WNN0 - Replacing Rear-Axle Anti-Roll Bar Bearing (Workshop Campaign)

Revision: This bulletin replaces bulletin Group 4 175/22 WNN0, dated January 24, 2023.

Vehicle Type: **718 Spyder (982) / 718 Cayman GT4 (982)**

Installation position of anti-roll-bar mount on rear axle (shown on the 718 Cayman GT4 RS Clubsport)

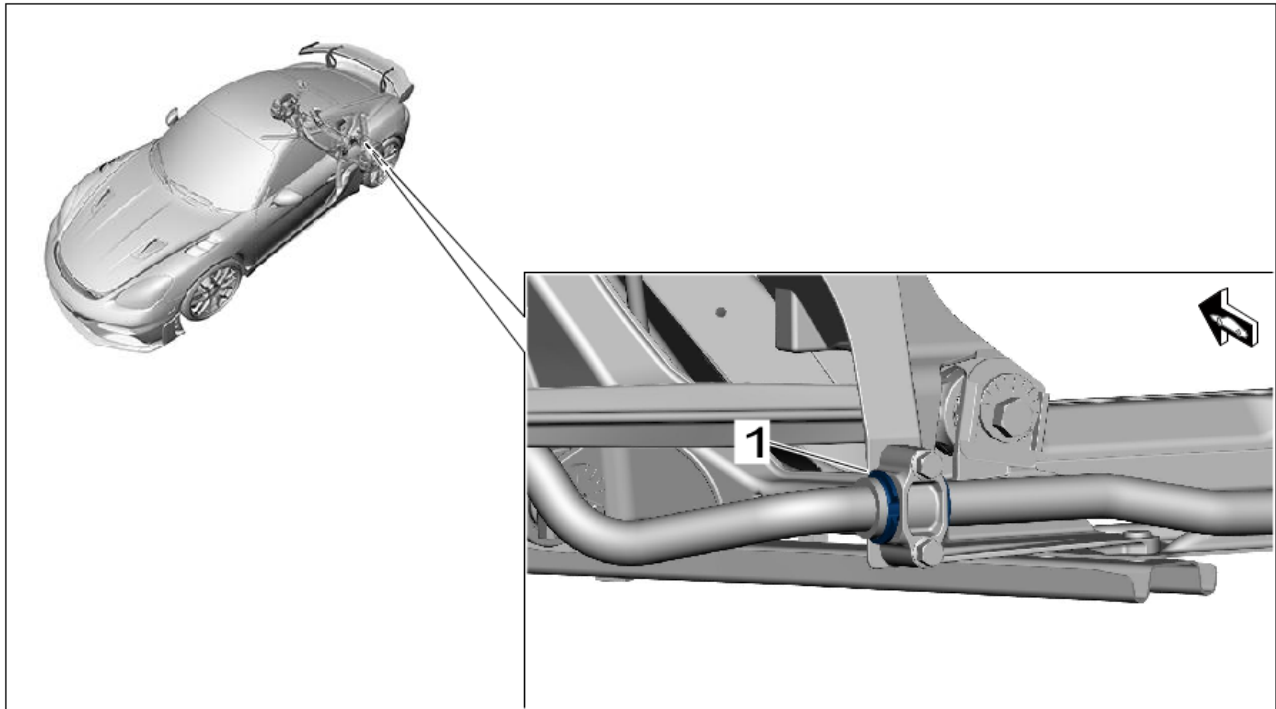
Information: **There is a possibility on the affected vehicles that stabilizer bearings were installed on the rear axle that do not meet the required specifications.**
This can be caused by acoustic anomalies (clatter) on the rear axle.

Action required: Replacing stabilizer bearing on rear axle.

1 – Stabilizer bearing rear axle

Replacing rear-axle anti-roll bar bearing

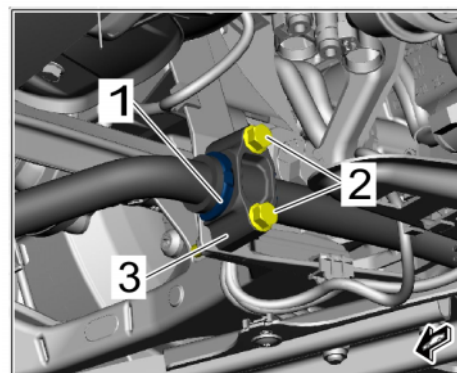
- Work Procedure: 1 Replacing stabilizer bearing rear axle ⇒ *Replacing rear-axle anti-roll bar bearing -1-*.
- 1.1 Unscrew the screws ⇒ *Replacing rear-axle anti-roll bar bearing -2-* and remove bearing support ⇒ *Replacing rear-axle anti-roll bar bearing -3-*.
- 1.2 Removing rear-axle anti-roll-bar mount ⇒ *Replacing rear-axle anti-roll bar bearing -1-*.
- 1.3 Position **new** rear-axle anti-roll-bar mount ⇒ *Replacing rear-axle anti-roll bar bearing -1-*.
- 1.4 Position the bearing ⇒ *Replacing rear-axle anti-roll bar bearing -3-*, screw in and tighten **new** screws ⇒ *Replacing rear-axle anti-roll bar bearing -2-*.

Tightening torque 20 Nm (14.8 ftlb.)
torque angle 90°
